From: [Cook, Pat \(DEQ\)](#)
To: [Benzie, Richard \(DEQ\)](#)
Subject: RE: Flint schematic in OEL
Date: Monday, October 05, 2015 8:31:19 AM
Attachments: [image001.png](#)

From: Crooks, Jennifer [<mailto:crooks.jennifer@epa.gov>]
Sent: Friday, October 02, 2015 12:46 PM
To: Busch, Stephen (DEQ); Prysby, Mike (DEQ); Rosenthal, Adam (DEQ); Benzie, Richard (DEQ)
Cc: Poy, Thomas
Subject: Flint schematic in OEL

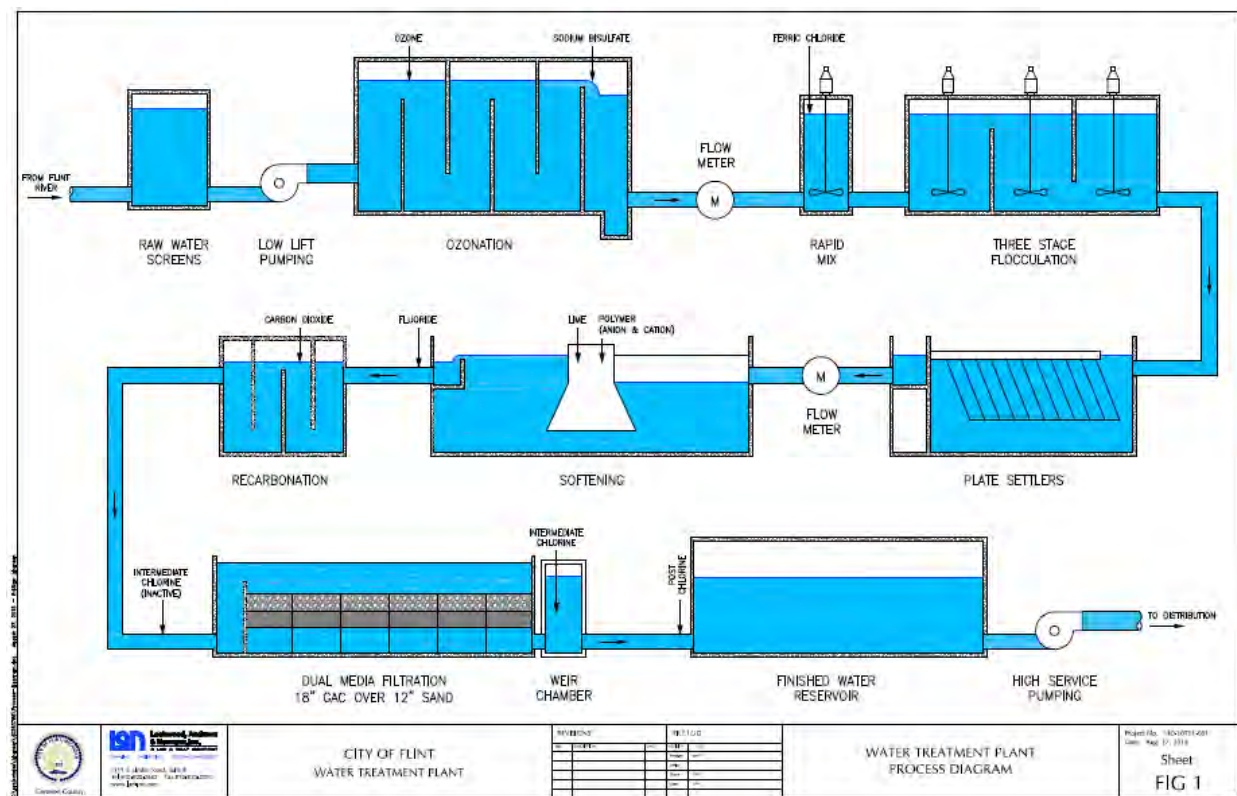
Have we routinely allowed filter plants to have only 12-inches of sand in there dual-media filters?

We have allowed it from time to time and in Flint's situation I believe it was allowed based on a quick and dirty pilot study.
